Design Review Subcommittee (DRSC)

Meeting Date: January 10, 2018

SUBJECT: **Minor Architectural Permit 17-299, Cook Residence**, a request to add a second story and remodel a residence with an existing legal nonconforming rear yard setback located at 206 West Avenida De Los Lobos Marinos. (Second Review)

Exhibit 2 – Proposed Elevations

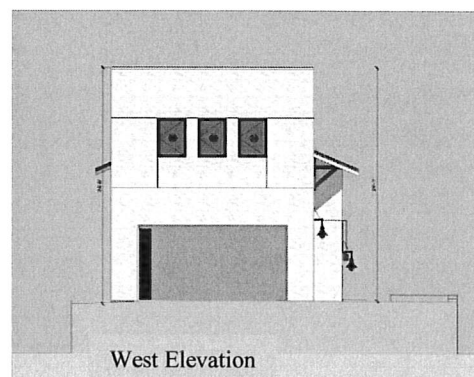
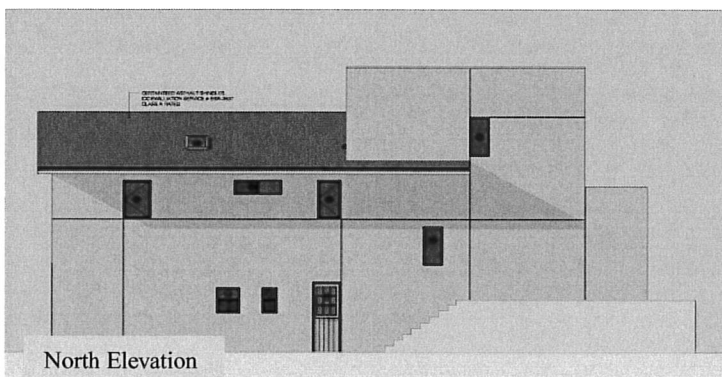
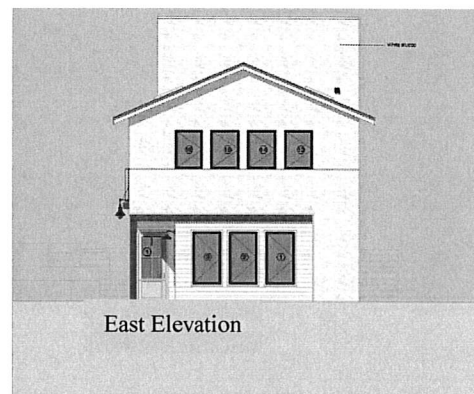
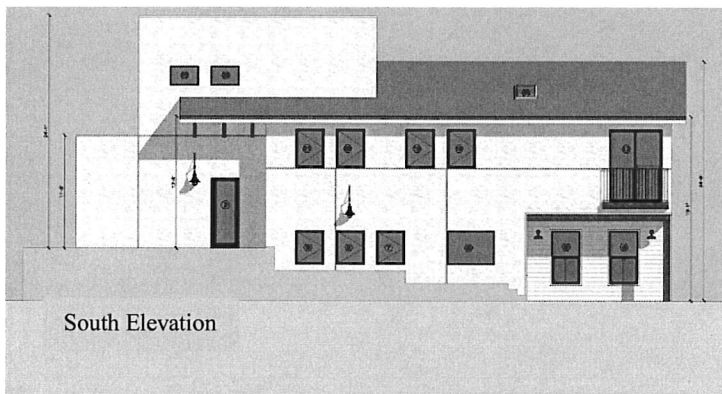
Design Guideline	Consistency Finding
<p>General Design Guidelines II.B: “All development proposals should demonstrate sensitivity to the contextual influences of adjacent properties and the neighborhood.”</p>	<p>Inconsistent. The second story addition has a scale and mass that is not in character with nearby structures, including the two stories residences on both sides of the site. The “box” character of the second story addition does not complement the existing style of Bungalow style of architecture or integrate with this style. The number, size, proportion and locations of windows is not symmetrical in any aspect. The context of the second story addition is contrary to existing second story buildings in the neighborhood.</p>
<p>General Design Guidelines II.B.3, Relationship to Neighboring Development: “Design buildings to be compatible in scale, mass and form with adjacent structures and the pattern of the neighborhood.”</p>	<p>Inconsistent. Same comments as above.</p>

<p>Avoid long and unrelieved wall planes. As a general principle, relieve building surfaces with recesses that provided strong shadow and visual interest. (Design Guidelines II.C.3)</p>	<p>Inconsistent. The north, south and west building elevations are unarticulated and stark with the exception of windows.</p>
<p>Varied roof heights are encouraged. (Design Guidelines II.C.3.b)</p>	<p>Inconsistent. The roofline is varied. However, the square design of the roof at the rear of the residence does not integrate with the existing structure but interrupts and separates the roof line without transition or flow.</p>

Staff recommends a redesign of the second story addition to address the massing and architectural element issues described above. Staff seeks DRSC comments and recommendations. Based on the concerns summarized in this report, staff recommends that this item be reviewed by the DRSC after the plans are revised.
